Your Ref: SSD-45373580

**Proposed New Rouse Hill Hospital Concept and Stage 1 Early Works
Lots 311 and 312 DP 1274392, Commercial Road, Rouse Hill**

In regard to the proposed new Rouse Hill hospital concept and Stage 1 early works, the following comments are provided for your consideration as part of the assessment of the DA. I note that some of the comments below are the same as matters raised in previous correspondence relating to the SEARs dated 04 July 2022.

Figure 1. SIDRA Intersection Layout of Windsor Road and Commercial Road (source: Arup's traffic report)

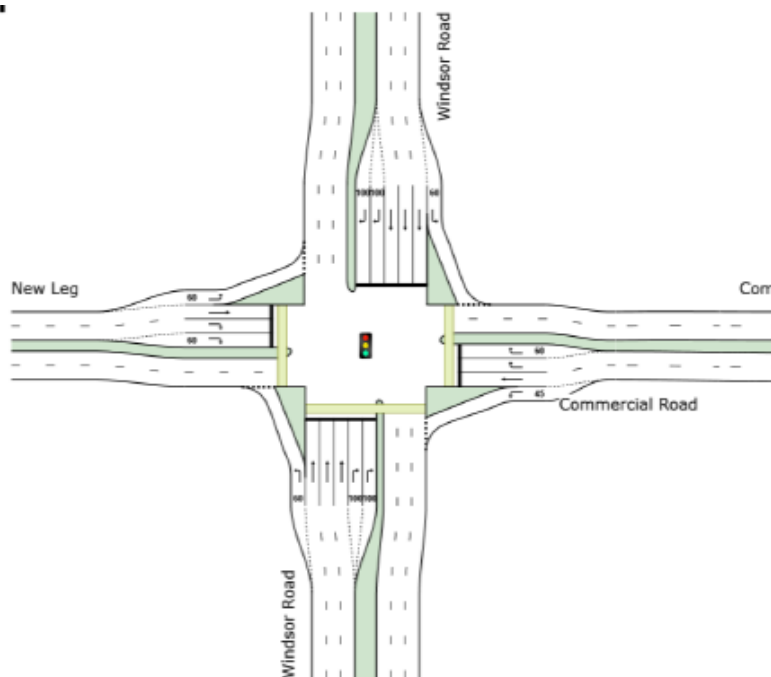
- a. The traffic report states that the traffic generation of the proposed hospital is based on profiles derived from surveys of other similar hospitals and formulas developed for calculating the staff, patients, and visitors trip generations. However, no details of the surveys and calculation of the trip generation have been provided with the report.
- b. The intersection layout used for SIDRA modelling analysis for the year 2026 and 2036 (Figure 1) shows Windsor Road at the intersection with Commercial Road has three (3) through lanes in the north and south bound directions with an additional forth leg on the western side of the intersection.

- c. The intersection of Windsor Road and Commercial Road is currently a T-intersection with no western leg and only has two through lanes on the northern and southern legs. The traffic report states that this configuration is based on future intersection layouts previously discussed with TfNSW and The Hills Shire Council. Council's Traffic Team are not aware of this proposal and discussion.
- d. It should be noted that the addition of the western leg including the lane configuration is not in line with the current Cudgegong Road Station (Area 20) Precinct Plan as shown in Figure 2 and poses concerns with regard to the short distance between the traffic light and the roundabout.

Figure 2. Cudgegong Road Station (Area 20) Precinct Road Hierarchy Plan (source: NSW Department of Planning and Environment [website](#))

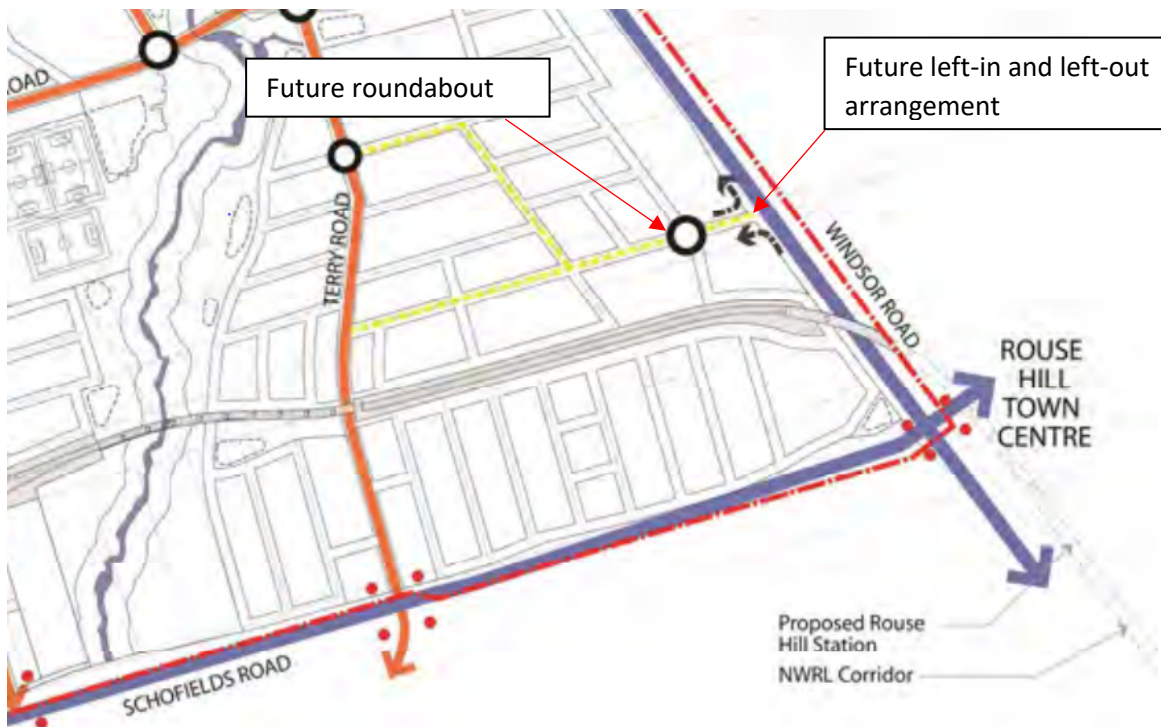
- a. Windsor Road intersection needs to be upgraded to provide three lanes in either direction. A new sub arterial standard fourth leg is shown on the western side of the intersection and the road hierarchy for this road is not consistent with the Tallawong Precinct Plan (see attached). The Tallawong Precinct plan shows this road as a local road with left in/left out access at Windsor Road. There is also an intersection with a proposed roundabout near Windsor Road.

Figure 5. Future intersection layout of Commercial Road and Caddies Boulevard (source: Arup's traffic report)

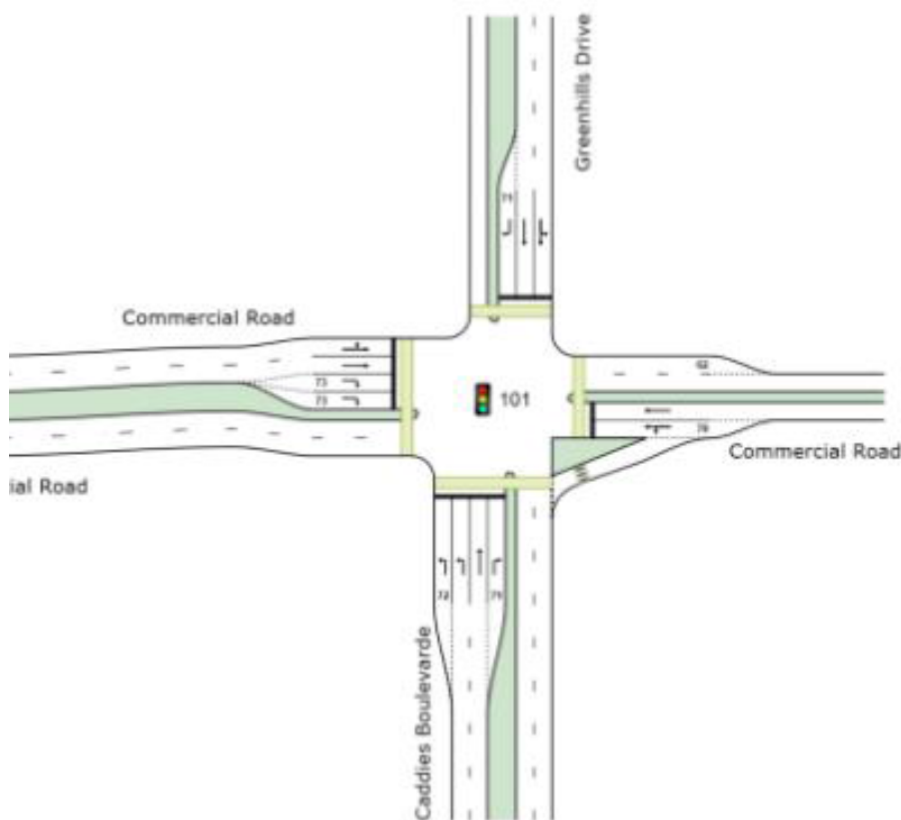
- h. Section 3.5.1 refers to additional residential demand which was therefore added to the future traffic. The report is to be updated to show the traffic volume for both i.e. before and after the residential demand was added for Year 2026 and Year 2036. The report is also required to address the future traffic volume in a network layout as per Figures 3-6 and 3-7 shown in the report.
- i. As the new leg in Windsor Road and Commercial Road intersection needs to be updated, the Trip Distribution is also required to be reviewed. The report suggests 7% from the West via the new Area 20 development.
- j. All modelling software files are required to be submitted with the updated report.
- 8. Right Turn Bay to the Main Hospital Road

Figure 3-3: Concept sketch of upgraded Commercial Road / Main Hospital Road intersection

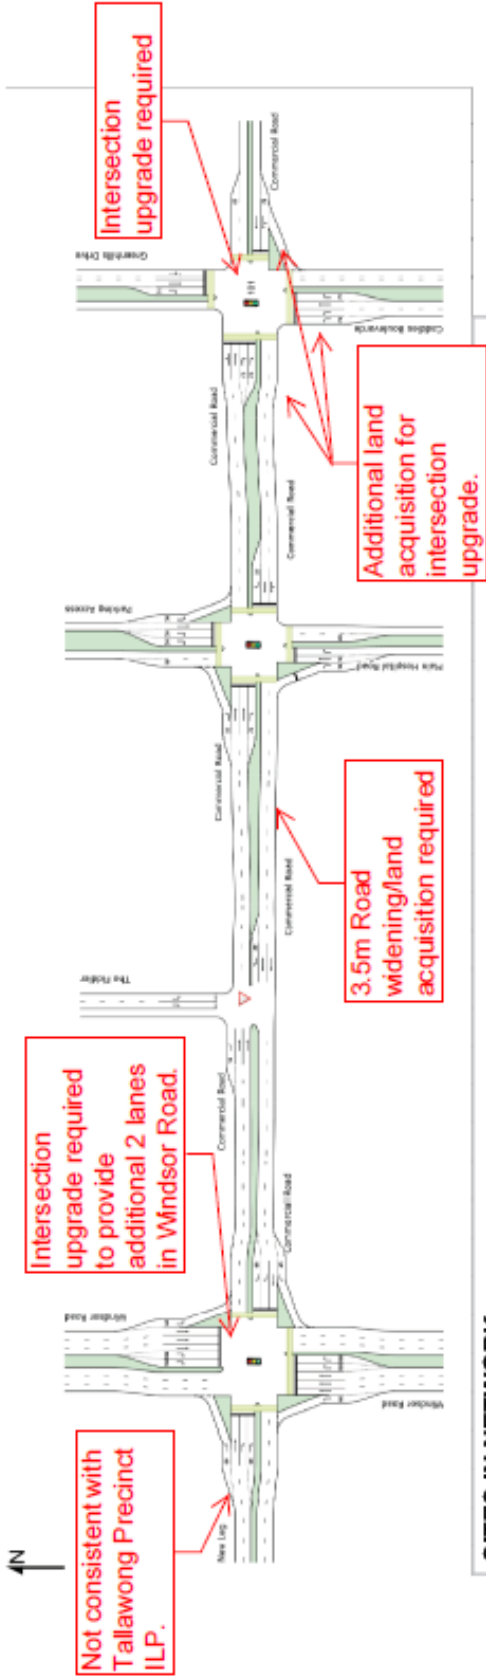
- b. A 70 metre right turn bay is required on Commercial Road at the Main Hospital Road. To provide this and to also maintain the existing right turn bay into The Fiddler, the road will need to be widened by 3.5 metres on the hospital/Endeavour Energy side as shown on the attached concept sketch.
- c. Caddies Boulevard intersection requires a significant upgrade. This upgrade will require additional land acquisition as shown on the attached concept plan.
